Mr. Steven Baggett  
Sealed Source Safety Section  
Source Containment and Devices Branch  
Division of Industrial and Medical Nuclear Safety, NMSS  
U. S. Nuclear Regulatory Commission  
Washington, DC 20555

22 August 1996

Enclosed, please find the additional information for approval of the Amersham J-tubes and rigid source stops. The information is presented in the same order as in your letter.

FIG. 1

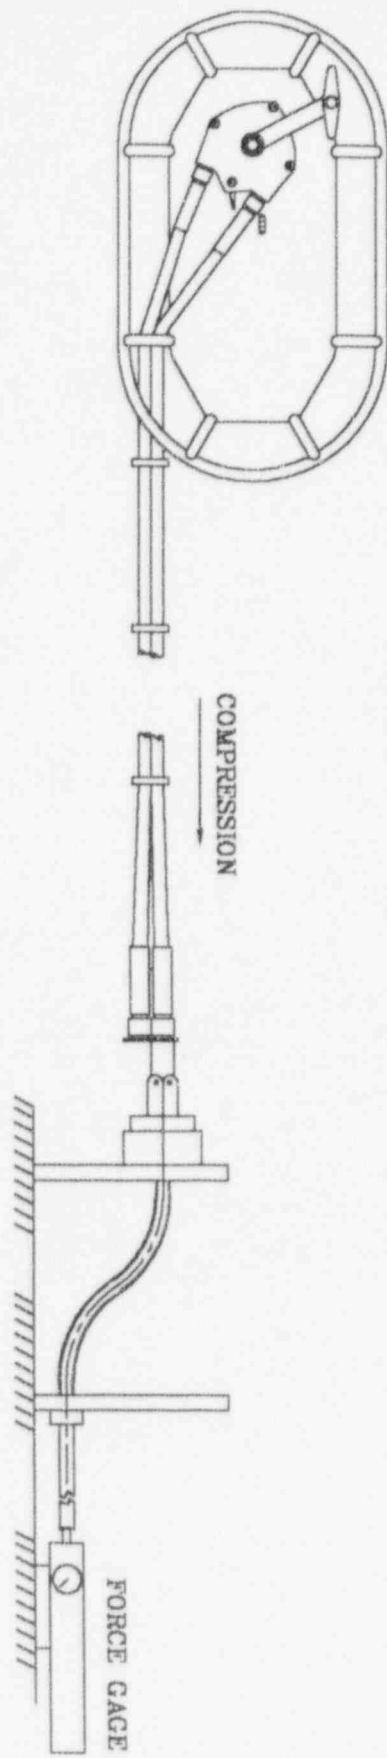
To measure the force in the exposing direction, a gauge was attached to the end of a seven foot guide tube to act as a source stop. A twenty five foot reel type control was attached to the input side of a 660 style "s" tube and the seven foot guide tube was attached to the output side of the "s" tube. The twenty five foot control and the seven foot guide tube were chosen because in previous tests it was found that the longer the control and guide tubes the smaller the force on the teleflex cable. This is because the guide tube and the control housings are flexible and they contract and act as a shock absorber when the source is at the extreme ends of its travel. (See figure 1)

If we multiply this average force by the four inch length of the crank arm of our control we get a maximum of 25.6 in lbs or 2.1 ft lbs of torque in the exposing direction.

FIG. 2

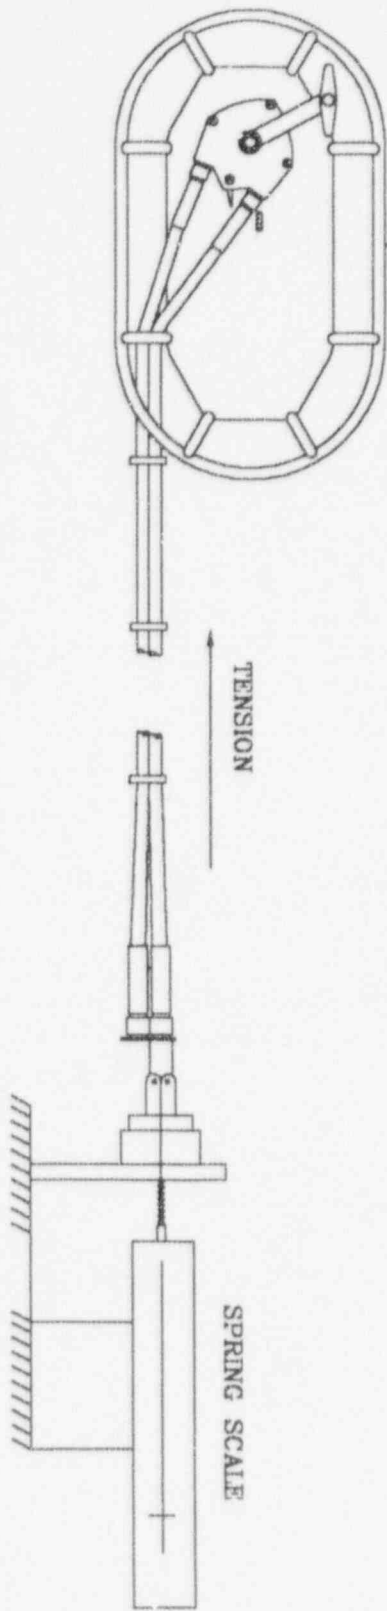
To measure the force in the retracting direction a spring scale was attached to the end of the teleflex drive cable after the cable passed thru the "s" tube and the twenty five foot control. (See figure 2)

Multiplying this average by the four inch crank arm we get a maximum of 116.8 in lbs or 9.7 ft lbs of torque in the retract direction.

TITLE J TUBE DESCRIPTIVE

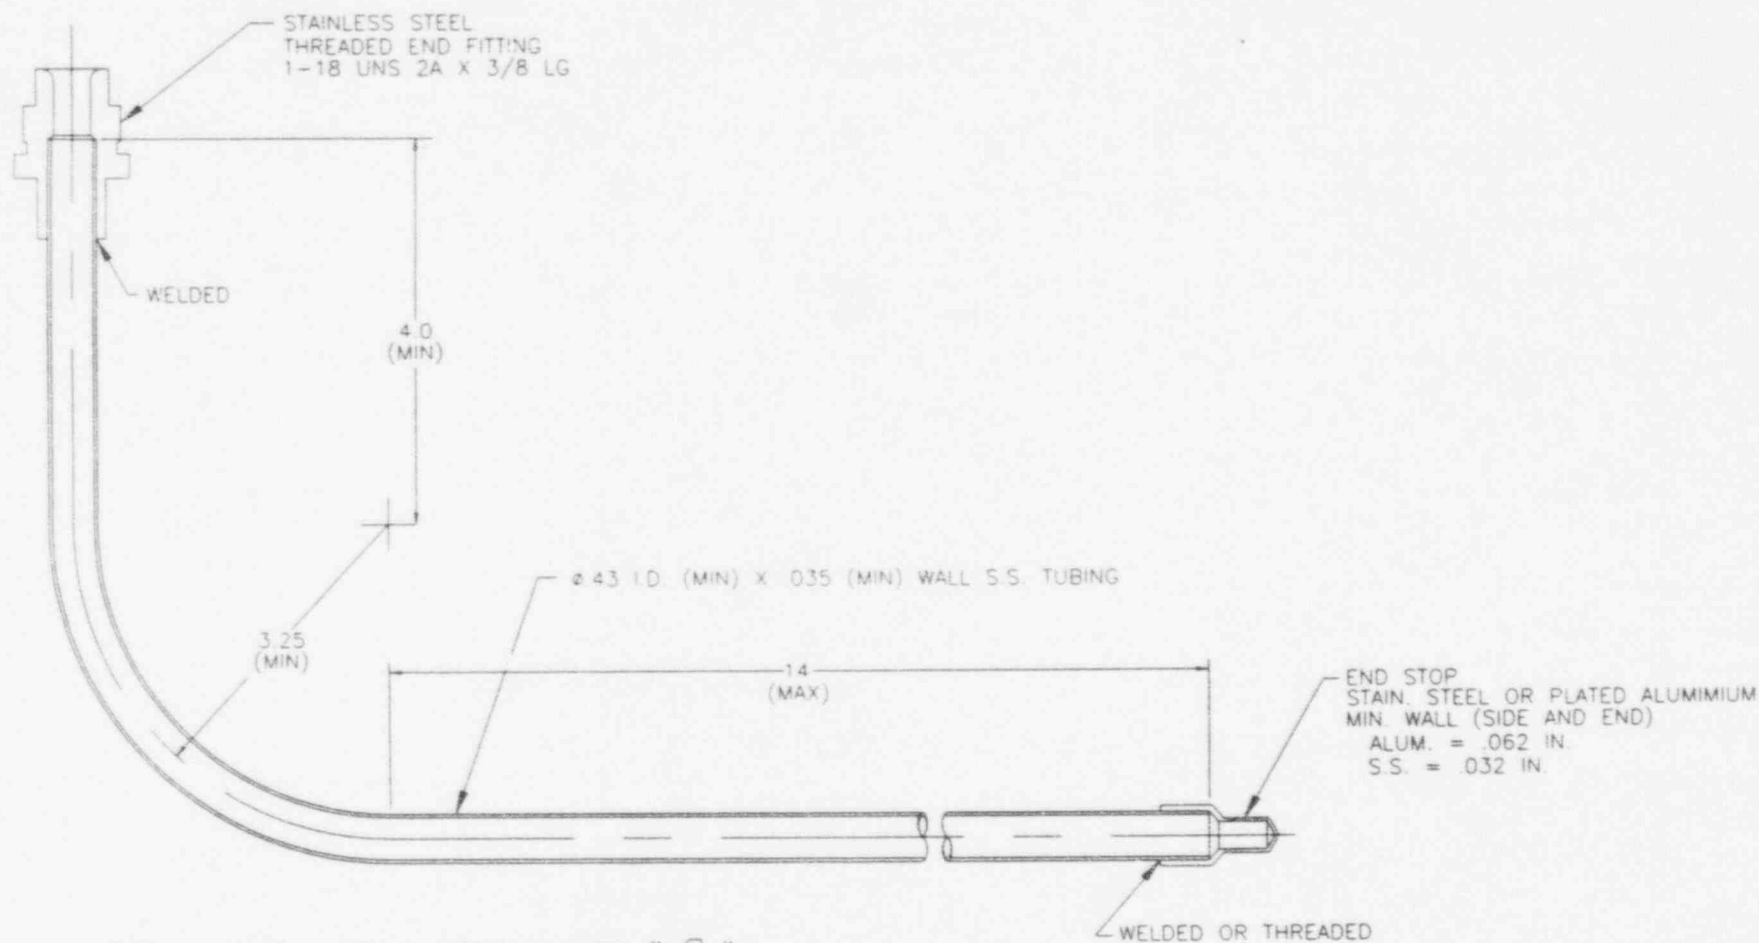
1. We are not familiar with the details of the medical source scenario that you referenced concerning dissimilar metals. We have not experienced any reported problems relating to the use of these metals together. However the vast majority of J-tubes we have manufactured are constructed completely of steel and do not use aluminum. We have updated the drawing to reflect the use of plated aluminum for the source stop if it is ever used in conjunction with steel.

2. See response to number 1 for Model 660 camera.
3. We have updated the drawings for J-tubes and jet engine probes to help clarify the difference between a J-tube and a jet engine probe. The J-tubes will easily pass the crush test as prescribed by ANSI as long as the minimum specifications as stated in drawing R JTUBE Revision B are met, ie 0.035 inch minimum wall thickness stainless steel tubing, as referenced in Test Plan number 44. In addition we have specified a maximum length of seven feet for the J-Tube.

- NOTE: 1. MARK WITH AMERSHAM OR "A"  
2. TOTAL NOT TO EXCEED 7 FEET

ADDED NOTE 2, PLATED ALUM.

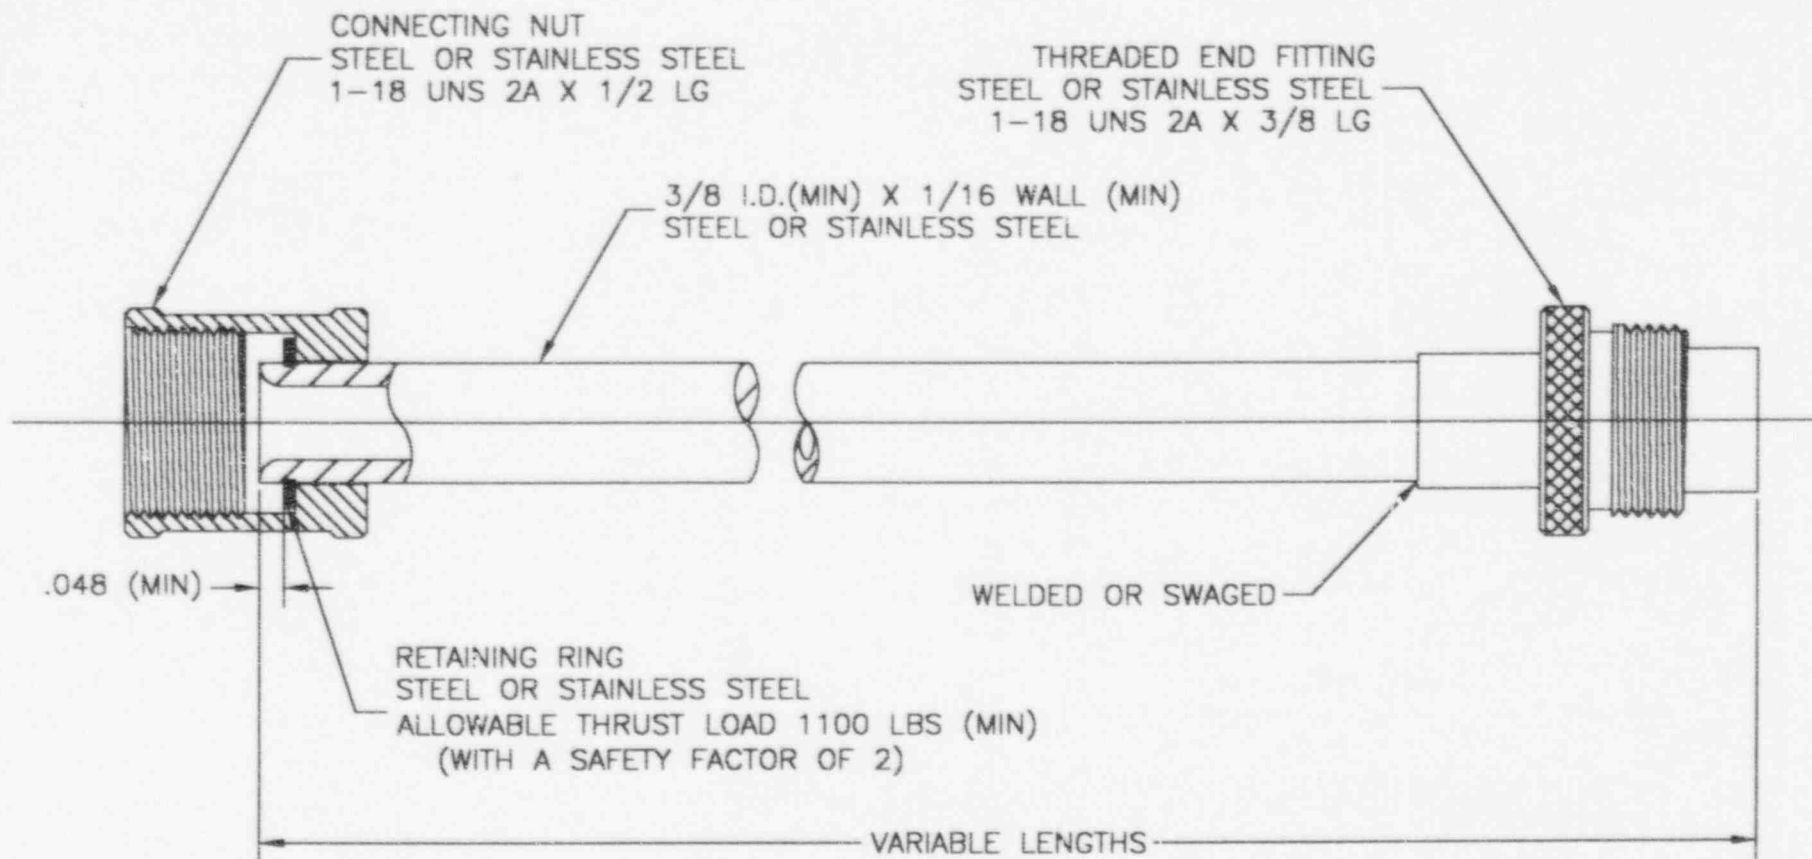
A drawing, R RIGIDTUBE revision A has also been included to depict the specifications of a rigid guide tube, ie anything greater than 10 times the length of the source capsule, an ordinary source stop meeting the specifications of drawing R RSTOP Revision A would then be threaded on the rigid guide tube. This category is necessary to cover applications other than J-tubes and jet engine probes such

as pipe centering devices and other specialized applications. As the construction of these meet the requirements of 10 CFR part 34 and ANSI N432 as indicated by Amersham test report 52, we request approval against 10 CFR Part 34.

I conclude that a rigid source guide tube assembly with a minimum of 3/8 ID and a minimum wall thickness of 1/16 in. manufactured per drawing R RIGIDTUBE meets the requirements of 10 CFR Part 34 section 34.20 (c) (5) & (8)

INITIAL RELEASE	<i>C. Souphan</i>	20 AUG 96	A	TITLE	JET ENGINE PROBE		
DESCRIPTION	APPROVALS	DATE	LTR	SIZE	DWG. NO.	REV	
				A	R 727	A	
REVISIONS				SCALE: NONE	SHEET 1 OF 1

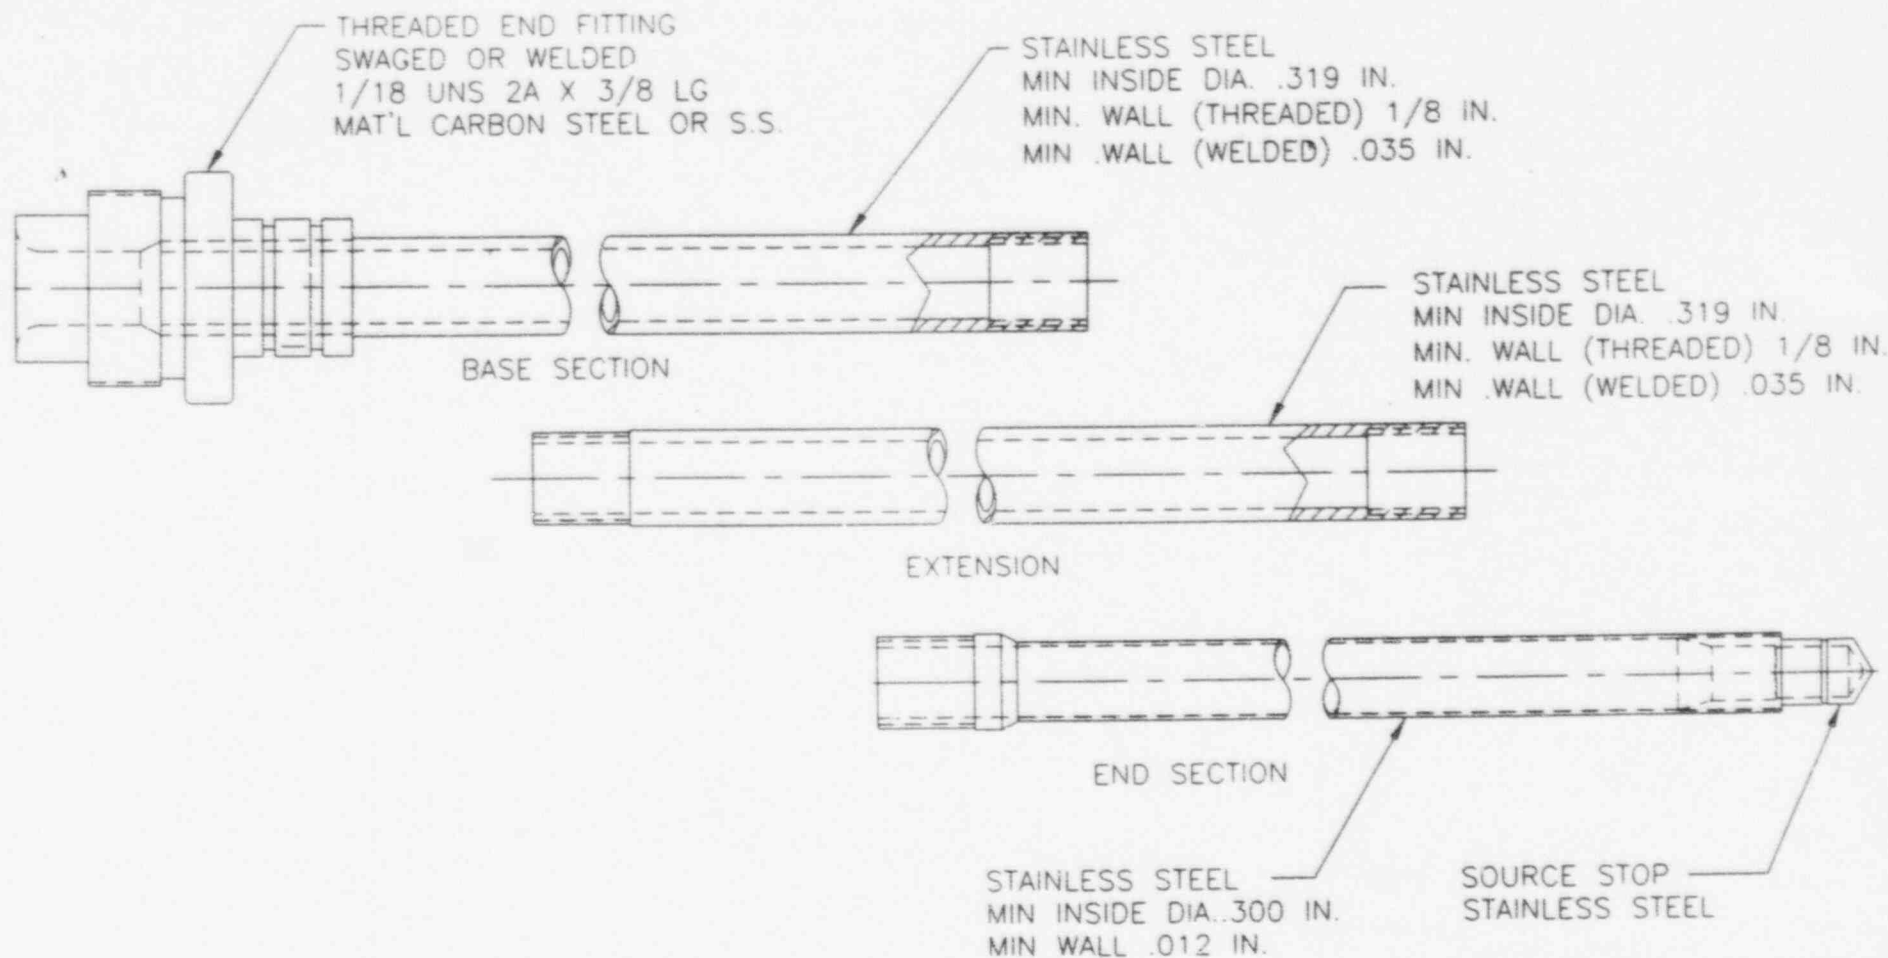
As shown in the drawing R 727 Revision A, the jet engine probe can be many different lengths depending on the application, typical lengths are seven to ten feet. The jet engine probes as described in drawing R 727 passed all of the prescribed ANSI N432 tests except for the crush test as described in ANSI N432. These details were provided in Test Plan number 44. The only section of the jet engine probe that did not pass the crush test was the end section due to the thinner wall. Due to their use in a protected environment ie inside a jet engine and the current practice of performing a QC/operational check on the probe prior to use, it is very unlikely that there will be a problem during use. We would recommend that they be considered for an exemption from the requirements.

- NOTE: 1. LENGTH OF SECTION VARIES WITH APPLICATION  
2. SECTIONS MAY BE THREADED OR WELDED TOGETHER  
ALSO CAN BE MADE AS ONE PIECE
